November 15, 1972

## FRONT AXLE ASSEMBLY 1973 MODEL Z-90

This bulletin will clarify the correct assembly for the 1973 Model Z-90 front wheel and axle.

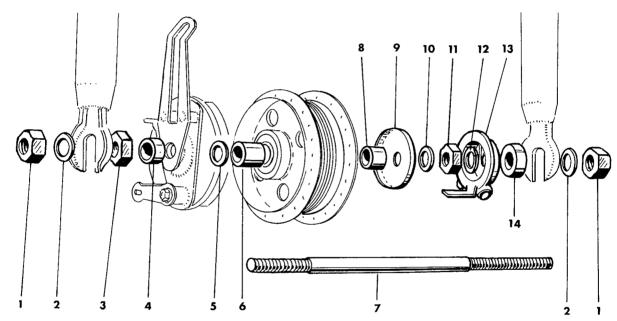
The motorcycle front axle and wheel are removed from the front fork for shipment. Axle washers, spacers and nuts will be found reassembled to the axle and boxed separately with the brake sideplate.

Follow the predelivery and setting up instruction sheet included with the crated motorcycle except for installing the front axle and wheel to the front fork. The correct installation is shown below. Parts are numbered in assembly sequence.

NOTE: If an extra thin shim washer (5) is included with the parts, it should be placed between (5 and 6).

- 1. NUT, 3/8" thick x 17 mm HEX.
- 2. SPACER, 1/8" thick x 7/8 O.D. x 7/16 I.D.
- 3. NUT, 1/4" thick x 19 mm HEX.
- 4. SPACER, 1/4" thick x 5/8 O.D. x 29/64 I.D.
- 5. SPACER, .040 thick x 3/4 O.D. x 15/32 I.D.
- 6. SPACER, 21/32" thick x 5/8 O.D. x 1/2 I.D.
- 7. AXLE

- 8. SPACER, 11/32" thick x 5/8 O.D. x 1/2 I.D.
- DUST COVER
- 10. WASHER, 1/8" thick x 3/4 O.D. x 7/16 I.D.
- 11. NUT, 1/4" thick x 17 mm HEX.
- 12. SPACER, .080 thick x 23/32 O.D. x 7/16 I.D.
- 13. SPEEDOMETER DRIVE
- 14. SPACER, 1/4" thick x 25/32 O.D. x 29/64 I.D.
